## TI\_2314: Change to the sensor module

iVario 2-S P, iVario L P, iVario XL P

19/05/2023

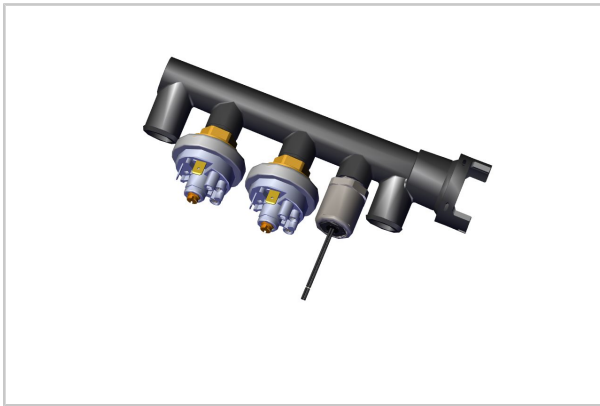
To further enhance the reliability of the units with pressure option, the sensor module and the 20 mbar and 350 mbar pressure switches have been modified.

In the new design, the pressure sensor is located between the two pressure switches. The pressure switches are held in place by two clamps and a support plate and are no longer screwed tight. This significantly increases the pressure measurement area.
